FINAL REPORT

Review of Ballast Water Tank 94 and Crude Oil Storage Tank 7 Out-of-Service Inspection Reports

PWSRCAC Contract # 5081.22-01

May 2024

Figure 4 – Tank 7 Annular Ring CP Ground bed Design

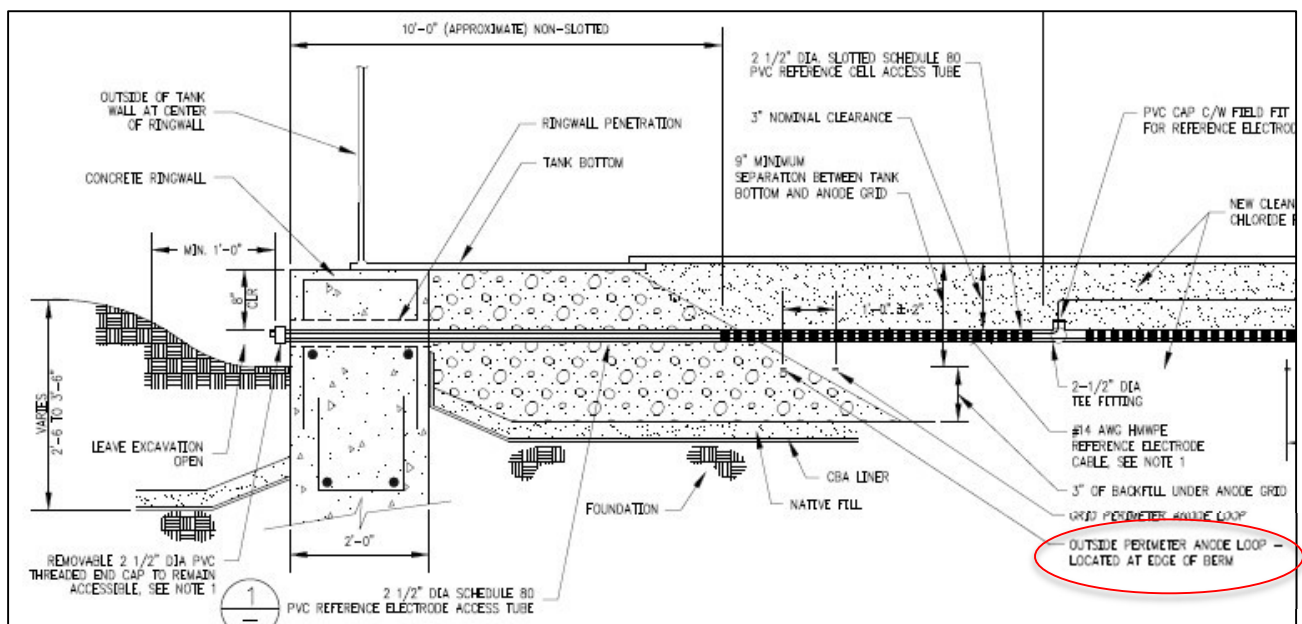
This anode configuration does not protect the annular plates and perimeter floor plates for the following reasons.

First, the annular plate and floorplate are welded together and therefore electrically continuous. The MMO loop intended to protect the annular plates will distribute current primarily via the lowest

resistance pathways. In this case, assuming similar backfill resistivity, the current will go to the closest steel, which is the regular floorplate steel, not the annular plate.

The ratio of floorplate surface area to anode length is significantly larger at the tank perimeter. Without the ability to drive the perimeter anode separately from the remainder of the groundbed, the CP current density to the perimeter floorplate and annular plate will be significantly lower than the rest of the floor.

A general rule of thumb used for designing for the uniform distribution of CP current for close coupled anodes, is to assume that the anode will distribute current to the steel surface in a (roughly) 120-degree arc of influence.¹ This rule of thumb is based on the resistance of the path length between the anode and structure. This is depicted below in Figure 5. As shown in the figure, the MMO loop intended to protect the tank perimeter plates will not provide protective current to the annular plate (also depicted in Figure 5).

The MMO loop that is dedicated for the annular plate and perimeter floorplates is tied to a single circuit that cannot be adjusted independently of the rest of the anode groundbed. Even if the system had the ability to independently power the MMO loop nearest to the annular plate, the resulting CP current will go predominantly to the perimeter floorplate and will not measurably impact the annular plate.

Figure 5 – Tank 7 CP System Perimeter Current Distribution

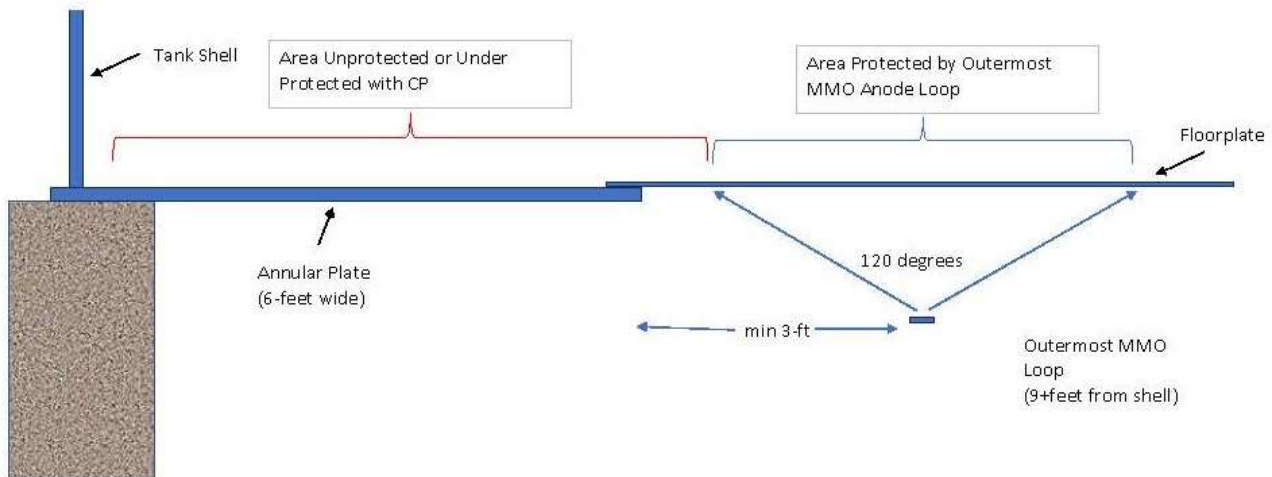
During the 2021 tank outage, 15 patch plates were installed due to bottom-side corrosion. Nearly all repairs were on perimeter floorplates, validating that the CP current being provided to the perimeter areas is insufficient and that water intrusion through the failed annular plate extension to ringwall seal is causing corrosion.

Figure 6 – Corrosion Rates for the Tank 7 Floorplates 2008-2021

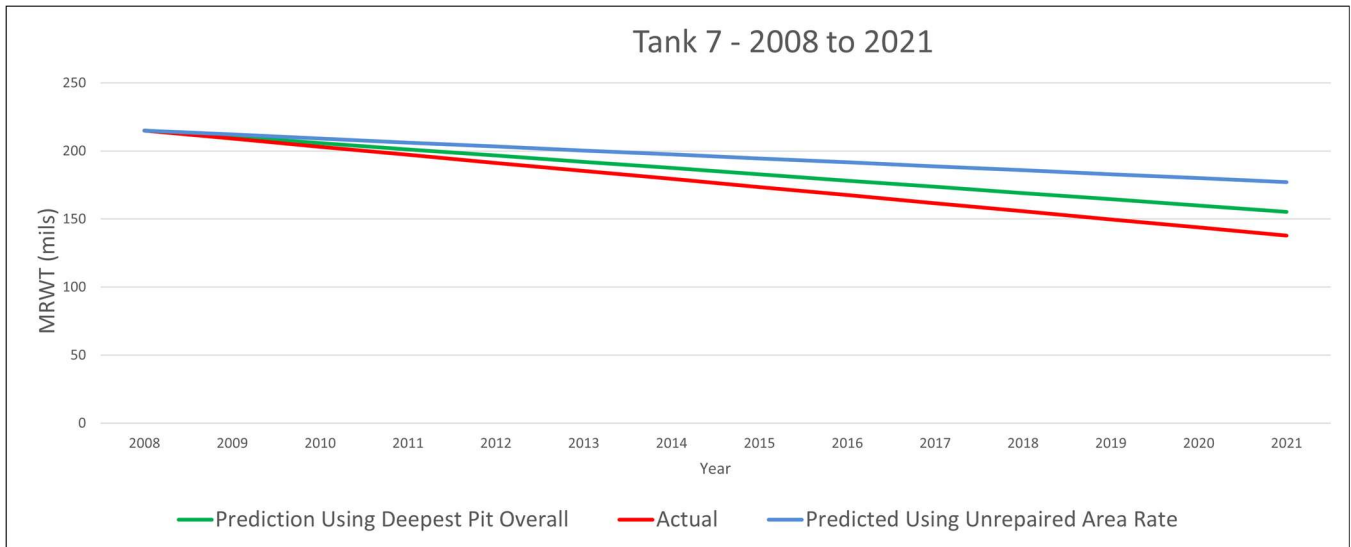
Figure 6 graphically presents the predicted 2008-2021 corrosion rates on the Tank 7 floorplate compared to the actual rates as discovered during inspection. The blue line represents the predicted floorplate corrosion rates based on the deepest unrepaired pit from 2008 (as allowed by API 653). That predicts that the 2008-2021 corrosion rate would have been 2.92 MPY with a minimum remaining floor thickness (MRFT) of 177 mils.

The green line in Figure 6 represents the predicted 2008-2021 corrosion rate based on the overall deepest pit discovered during the 2008 inspection.⁵ That predicted a soil-side corrosion rate of 4.58 MPY and a MRFT of 155 mils.

The red line in Figure 6 represents the actual 2008-2021 Tank 7 soil-side floorplate corrosion rate of 5.92 MPY and a MRFT of 138 mils.

The 2008-2021 Tank 7 floorplate corrosion rate predicted using the deepest unrepaired pit discovered in 2008, underestimated the actual corrosion pitting depth by 51%.

Figure 7 – Predicted Corrosion Rates for Tank 7 (2021-2041)

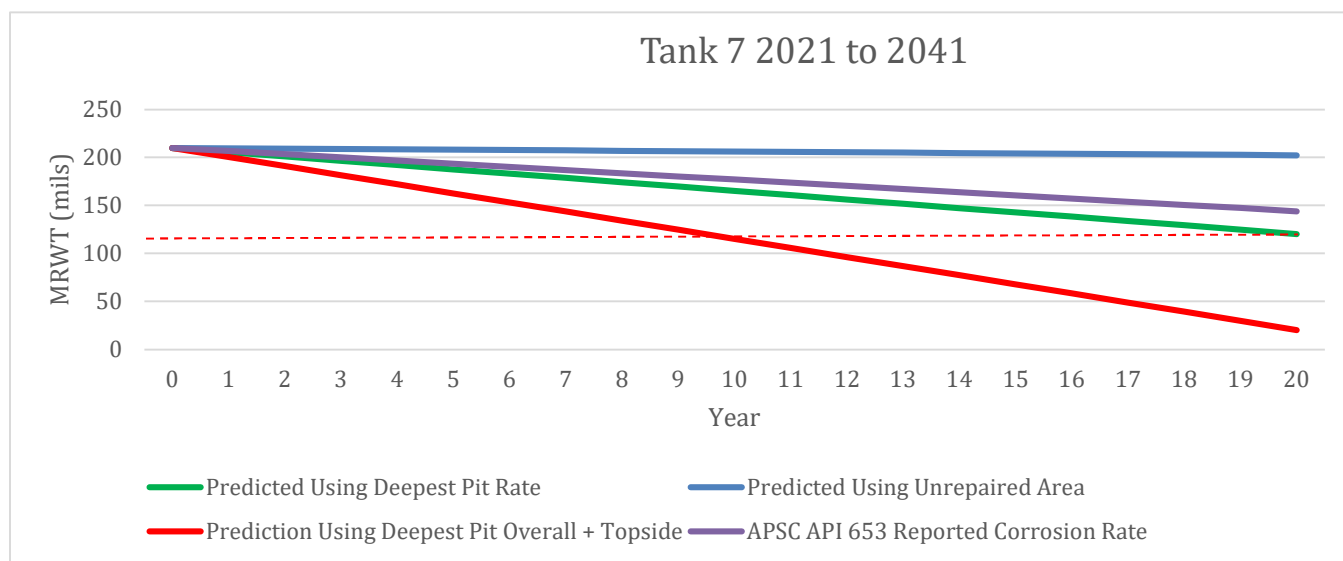
Figure 7 provides a graphical representation of the predicted floorplate corrosion rates for Tank 7 for the 20-year service interval that the APSC API 653 report recommends.

The blue line in Figure 7 represents the predicted Tank 7 2021-2041 floorplate corrosion rate based on the unrepaired areas from the 2021 inspection. Although allowed by API 653, empirical data for Tank 7 suggests that this significantly underestimates the actual corrosion rate.

The purple line in Figure 7 represents the predicted Tank 7 2021-2041 floorplate corrosion rate as reported in the APSC 2021 API 653 report. That rate does not appear to align with API 653 procedures.

The green line represents the predicted Tank 7 2021-2041 floorplate soil-side corrosion rate based on the deepest floorplate soil-side pit identified in the 2021 inspection. However, this does not include a topside corrosion rate, which is prudent given the age of the existing coatings.

The red line represents the predicted Tank 7 2021-2041 floorplate soil-side corrosion rate based on the deepest floorplate soil-side pit identified in the 2021 inspection, along with a 5 MPY topside corrosion component.

This approach, based on empirical data for Tank 7, predicts that if the tank is returned to service for 20 years, as the APSC API 653 report suggests, the floorplate thickness will fall below 100 mils between 2031 and 2032. Most critically, it also predicts that the floor will leak between 2040 and 2041, if action is not taken to correct current corrosion rates.

Figure 8 – Predicted Versus Actual Corrosion Depths for Tank 94

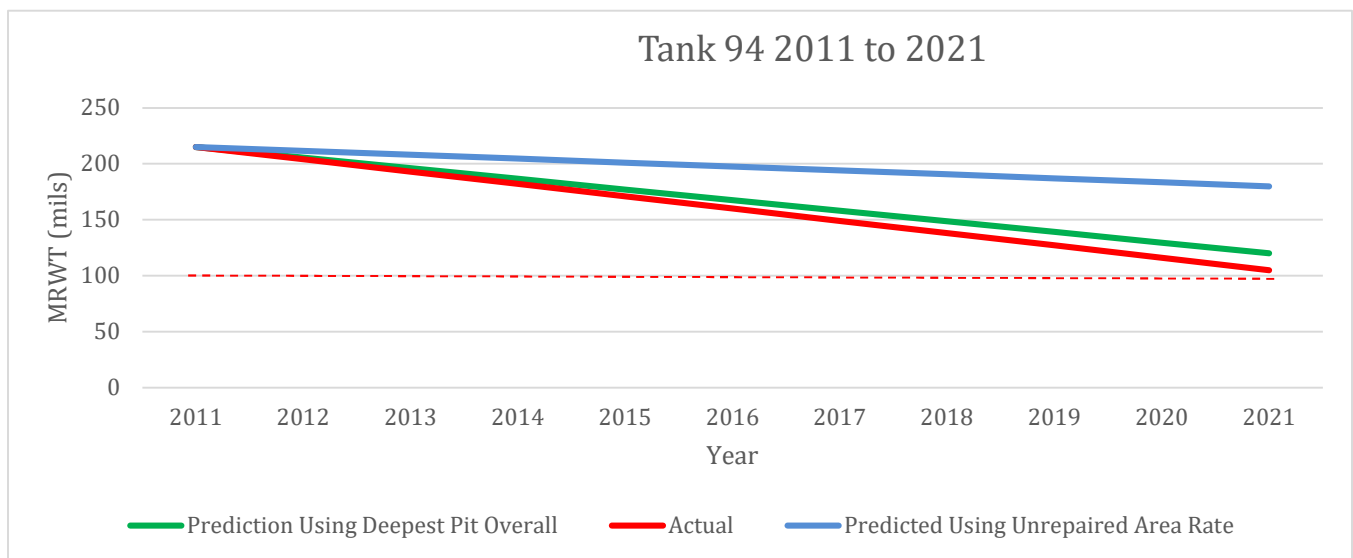
Figure 8 graphically illustrates the predicted and actual corrosion rates for Tank 94 for the 2011-2021 period. The blue line represents the predicted corrosion rate using the deepest unrepaired pit from 2011 (as allowed by API 653). Based on the deepest unrepaired pit after the 2011 inspection (215 mils RFT), the predicted corrosion rate for the Tank 94 floorplate was 3.5 MPY and the predicted deepest pit in 2021 was 180 mils RFT.

The use of the deepest pit from the 2011 inspection (155 mils RFT) to calculate corrosion rate and predict the deepest pit in 2021, resulted in a 2011-2021 predicted corrosion rate of 9.5 MPY and a predicted deepest pit (in 2021) of 120 mils RFT. This is represented by the green line in Figure 8.

The actual deepest floorplate pit identified in 2021 was 105 mils remaining wall thickness (RWT), representing a corrosion rate of 11 MPY. This is represented by the red line in Figure 8.

Using the 2011 deepest pit to define the 2011-2021 corrosion rate, the actual rate of corrosion was underestimated by 14%. Using the deepest unrepaired pit (from the 2011 inspection) to predict the Tank 94 floorplate corrosion rate between 2011 and 2021, the actual corrosion rate was underestimated by 68%.

Figure 9 – Predicted Corrosion Rates for the Tank 94 Floorplate Between 2021 and 2041

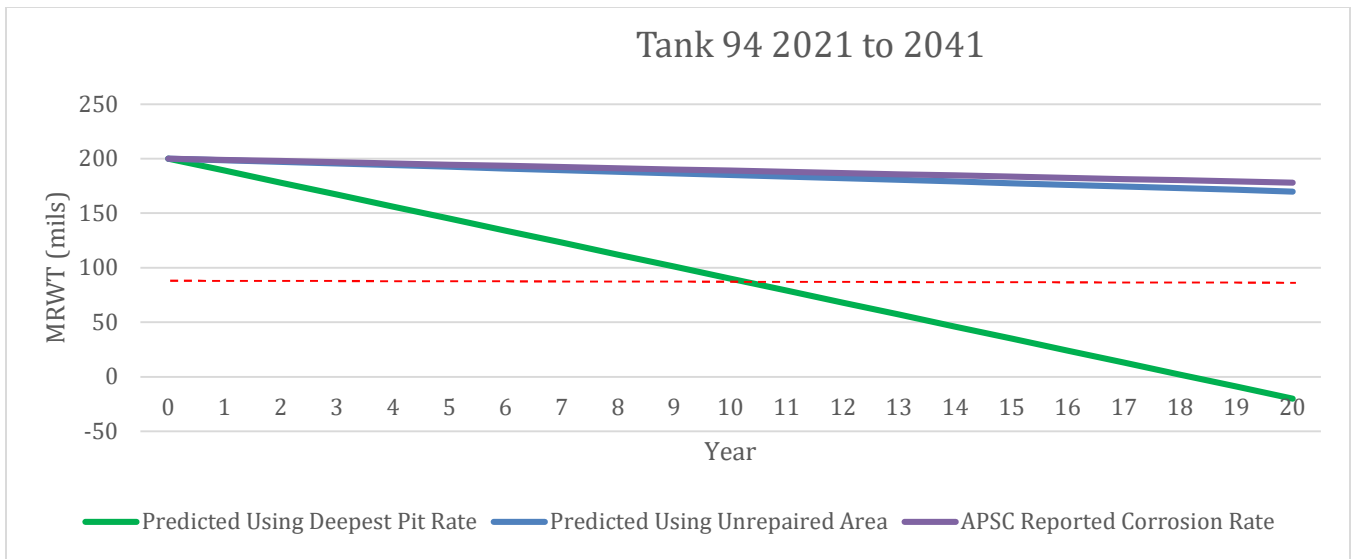
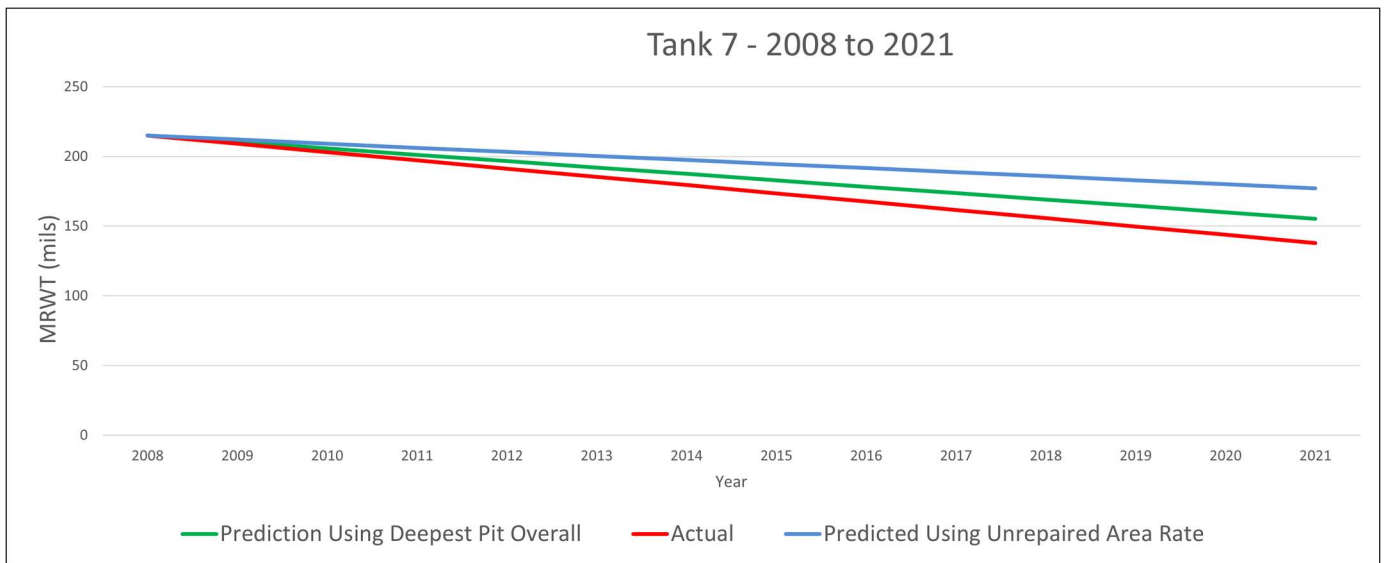
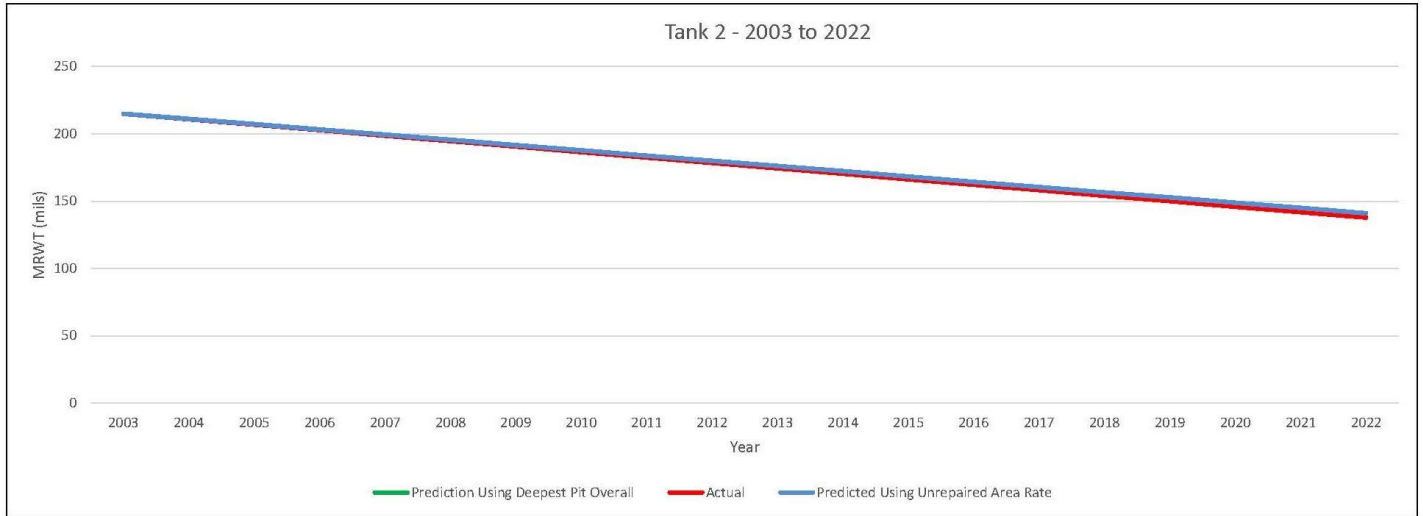
The APSC API 653 report recommends a 20-year service interval for Tank 94. Figure 9 graphically represents the predicted corrosion rates for the Tank 94 floorplate during a 20-year service interval. The blue line represents a corrosion rate based on the deepest unrepaired pit discovered in 2021 (as allowed by API 653). That predicts that the MRFT in 2041 will be 199 mils.

The purple line in Figure 9 represents the predicted corrosion using the 1.1 MPY corrosion rate reported by APSC in their 2021 API 653 report. That predicts that the deepest pitting on the floorplate will be 188 mils RFT in 2041.

The green line in Figure 9 represents the predicted corrosion rate using the deepest pit discovered in 2021, and the associated 11 MPY corrosion rate. Based on the 2011-2021 maximum corrosion rate, these calculations predict that the tank floor will thin beyond 100-mil RFT between 2030 and 2031. These calculations also predict that the tank will leak between 2038 and 2039.

Studies on APSC's tanks have shown that the use of the deepest pit to predict future corrosion rates, while more accurate than the use of pitting rates in unrepaired areas, usually underestimates the actual corrosion rate experienced in subsequent service intervals. Based on that, the green line in Figure 9 should not be viewed as a conservative assessment, but more likely an underestimation of the actual corrosion rates that should be expected on the Tank 94 floorplate going forward.
